STAFF RECOMMENDATION
1022 Acklen Avenue
December 18, 2019

Application: Violation/Show Cause; New Construction—Addition
District: Waverly-Belmont Neighborhood Conservation Zoning Overlay
Council District: 17
Base Zoning: R8
Map and Parcel Number: 1050933100
Applicant: Brian Layton
Project Lead: Jenny Warren, jenny.warren@nashville.gov

Figure 2: West elevation in original proposal, approved by the Commission in July 2018

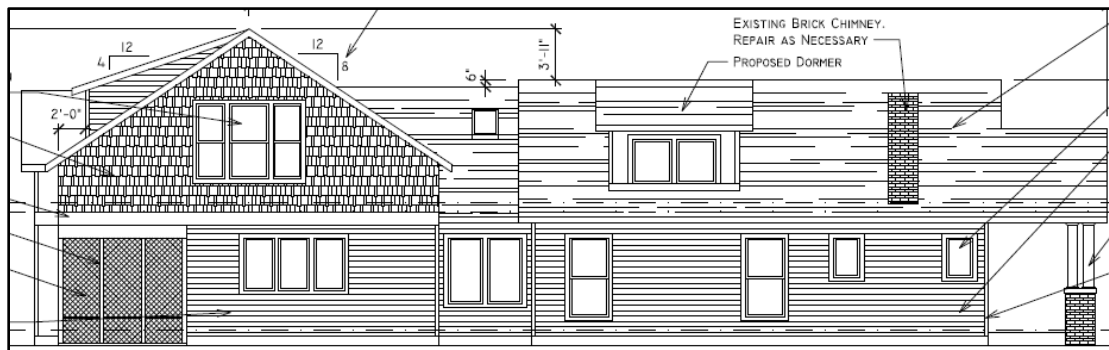
As approved, the project included adding a shed roofed dormer to each side elevation of the front-gabled historic house (Figure 2). Following the hearing, the applicant requested to add two additional dormers to the side elevations – these were both proposed for the roof of the addition, rather than the historic house itself. The revised plan was approved administratively by staff (Figure 3). Note that the middle dormer was proposed to be located fully on the front gabled connector portion of the addition and was to be very narrow, measuring about three feet, six inches (3’6”) wide.

In October 2019, MHZC staff was conducting a routine permit inspection and noted that the small middle dormer had been constructed much larger than it was approved. The result is that the dormer extends over the roof valley between the side and front gabled

portions of the addition and that the middle dormer effectively blocks the face of the rear dormer. Dormers traditionally sit fully on a single roof plane – a dormer spanning a valley is not a condition that is seen historically or that staff recommends. Further, this work is on a highly visible side elevation, facing onto 11th Avenue South.

Recommendation: Staff recommends that the middle dormer on the west elevation of the addition be reconstructed in a manner that matches the permit issued in July of 2018, as revised in August and November of 2018: HCP 2018038724 (Addition) within sixty days (60) of the date of this hearing.
